Meeting: **Planning Board**
Date: **February 08, 2021**
Time: **7:00 PM**
Location: **REMOTE MEETING NOTICE**

Subject: Four-Lot Subdivision, 76 Broad Street, Marlborough, MA
Response to Engineering Division review comments

DEFINITIVE SUBDIVISION PLAN

RE: Definitive Subdivision Plan – 76 Broad Street

DEFINITIVE
SUBDIVISION
PLAN

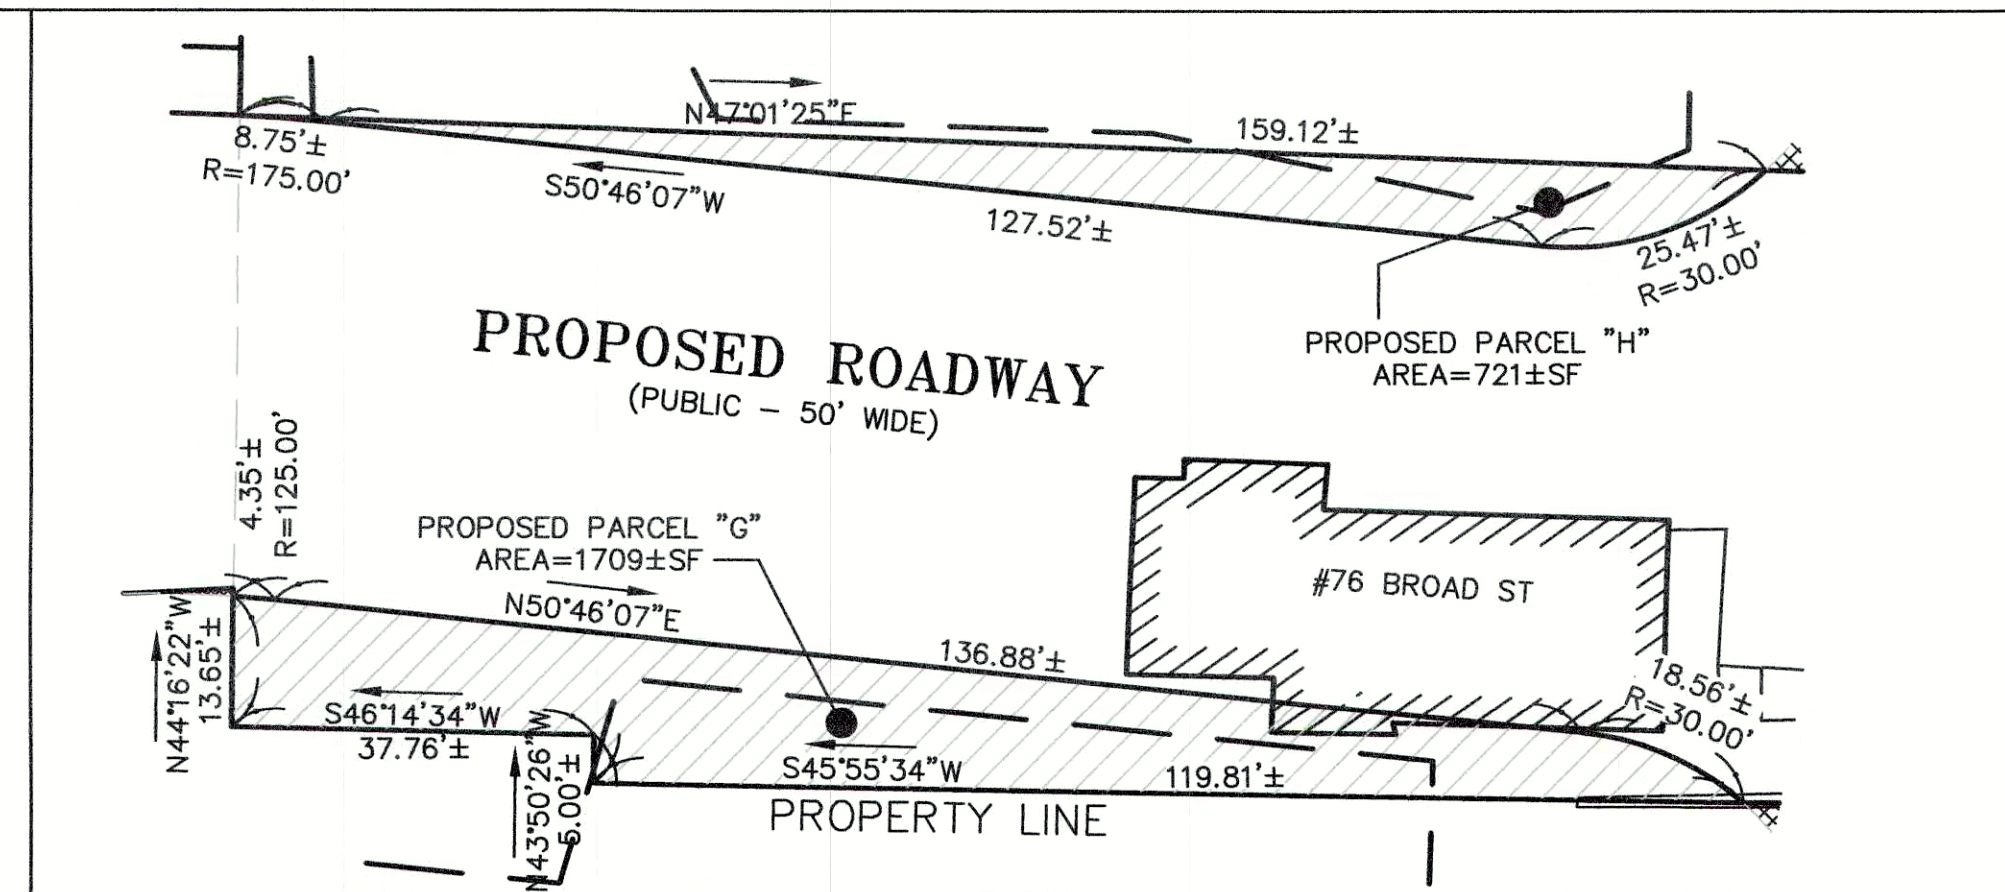
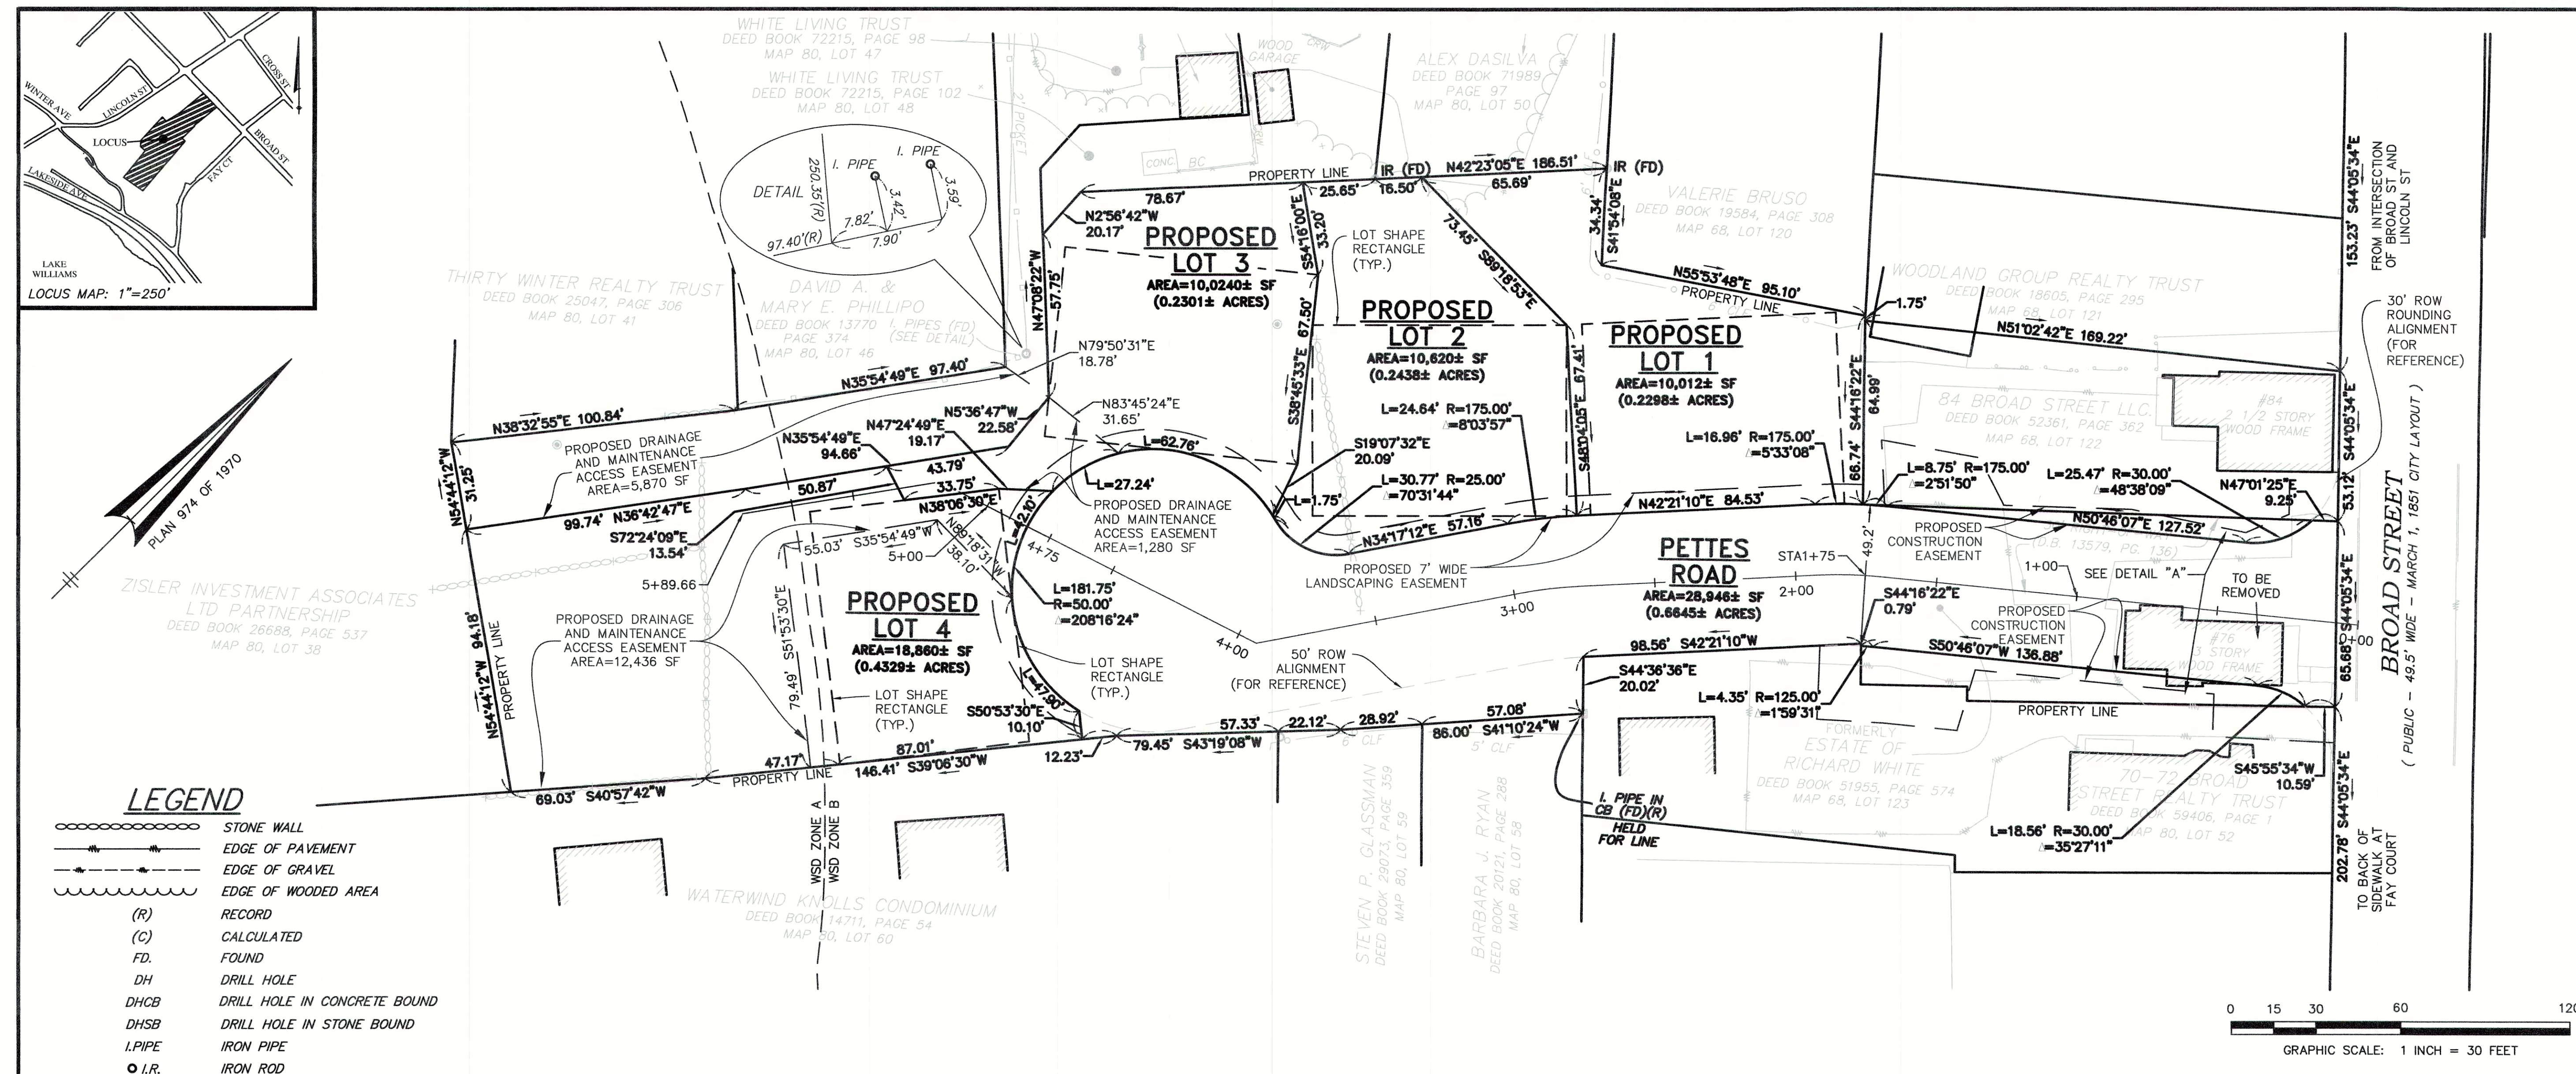
Page DS: Definitive Subdivision Plan. Mr. DiBenedetto responded to the comment requesting a letter that record owners of involved properties have granted permission for the use of their property in the design/use of the Definitive Subdivision Plan. A record letter will be provided prior to Board endorsement. Mr. DiPersio addressed the following comments: *The proposed location of the crosswalk and curbing and utility pole modifications along the intersection roundings at Broad Street eliminate the access for both properties at #70-#72 Broad Street and #84 Broad Street. The Definitive Subdivision Plan will need to show a construction easement on both #70-#72 Broad Street and #84 Broad Street over the area that will be affected by the change in the driveway location and changes to the parking areas for each of these two lots.* The City Engineer also commented that the plan should show that the new driveways have the proper grade.

GRADING AND
DRAINAGE
PLAN

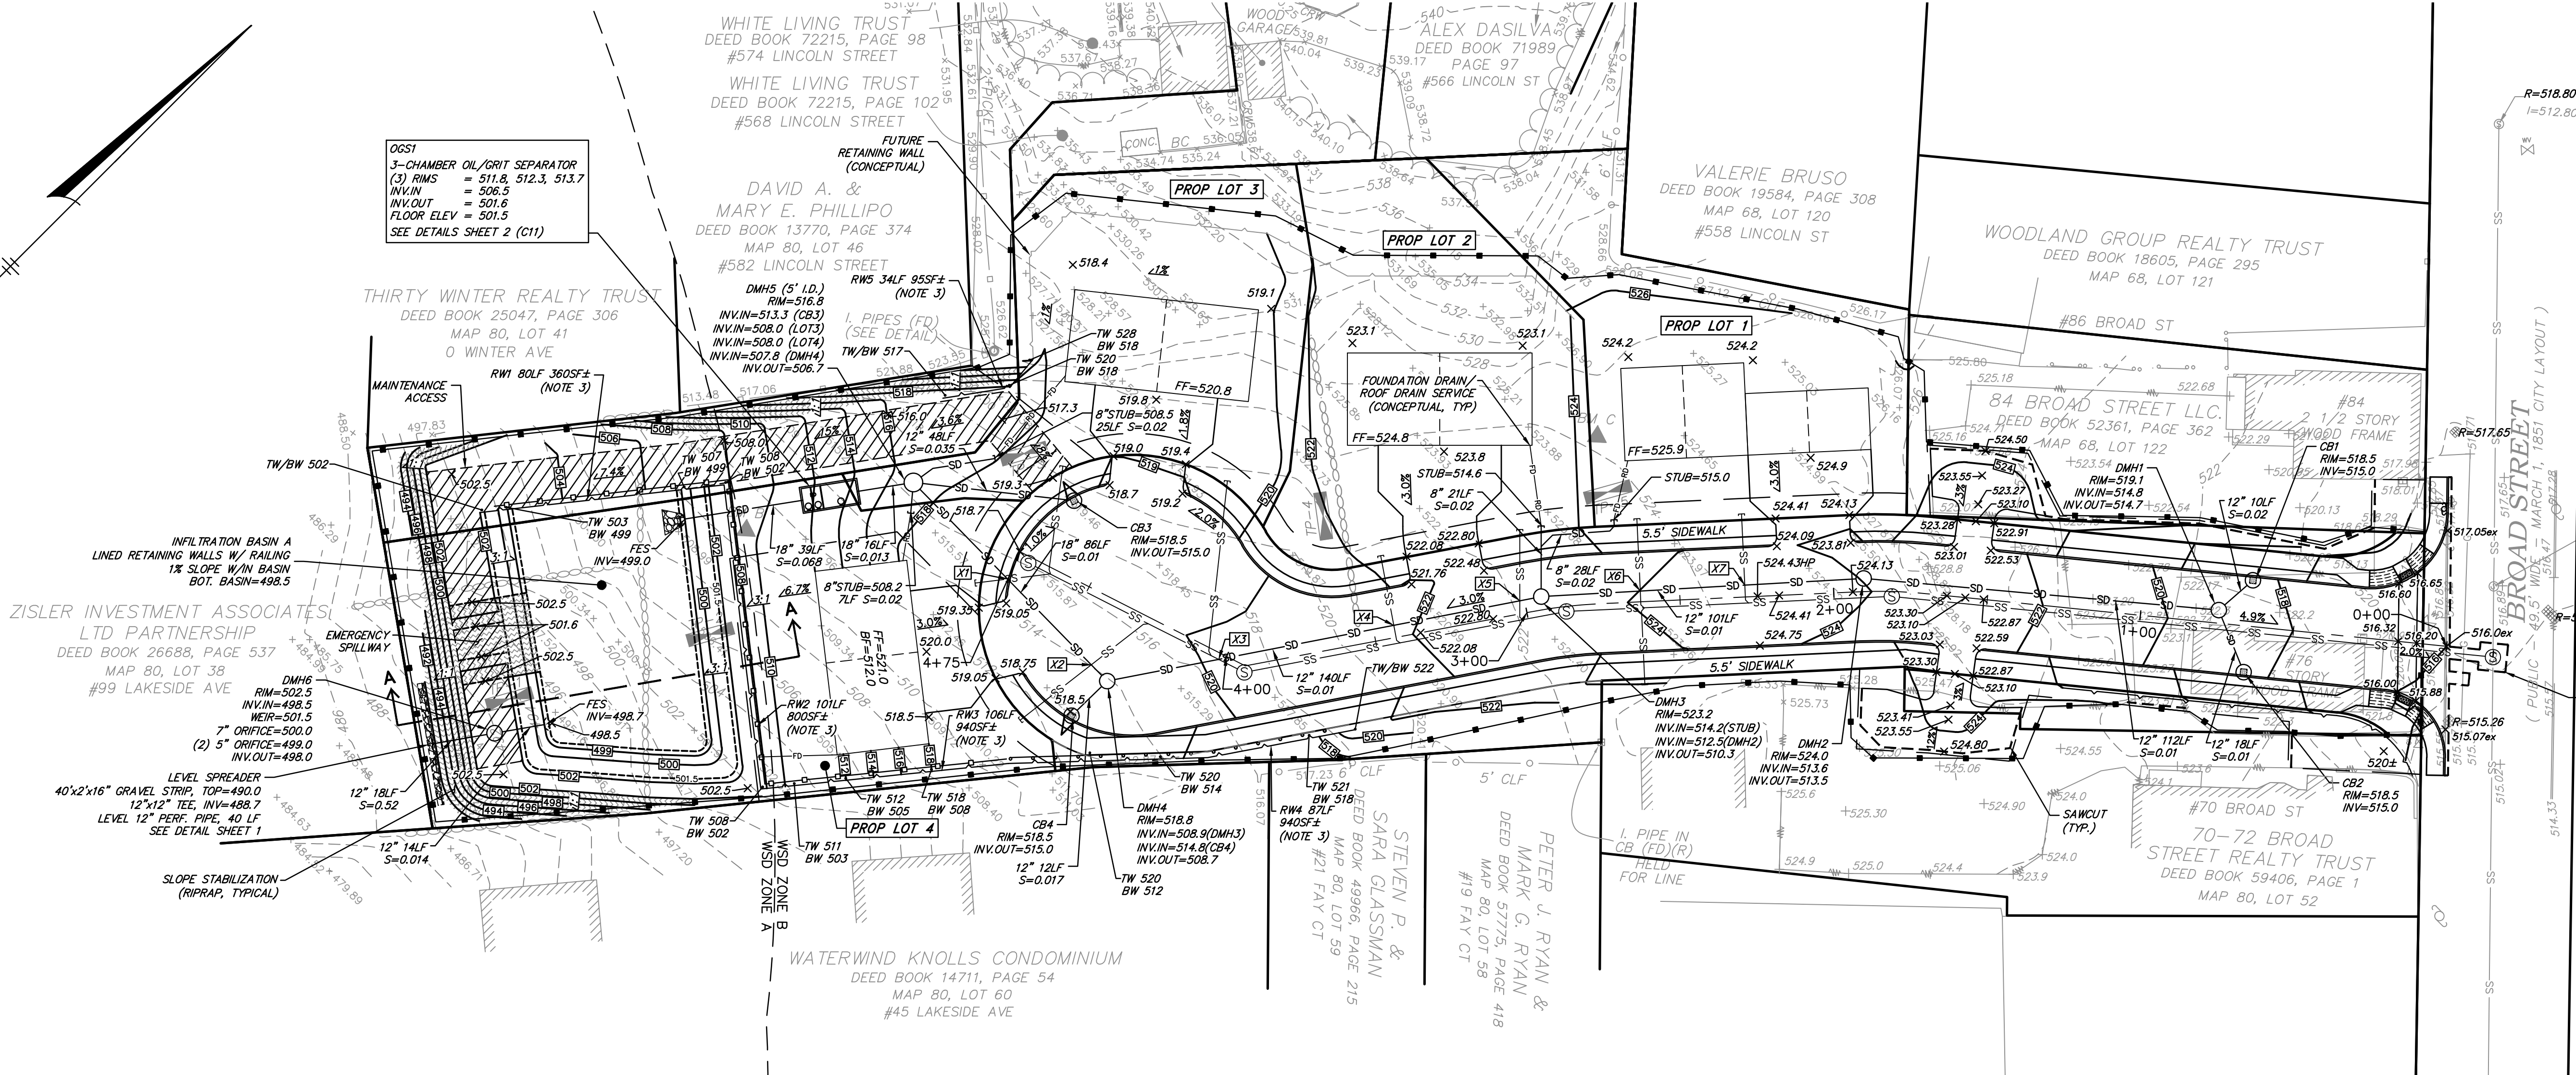
C6: Grading and Drainage Plan. The City Engineer said he preferred to have the drain line and sewer main swapped. Doing so would reduce the number of crossings. Mr. DiBenedetto said making that swap could lead to crossing issues elsewhere on the plan, since the swap would require the relocation of the water line and other utilities. On a motion by Mr. Elder, seconded by Mr. Russ, the Board voted to accept and file the correspondence and to refer the plan back to Engineering. Yea: Elder, Fay, Hodge, LaVenture, Russ, Fenby. Nay: 0. Motion carried.
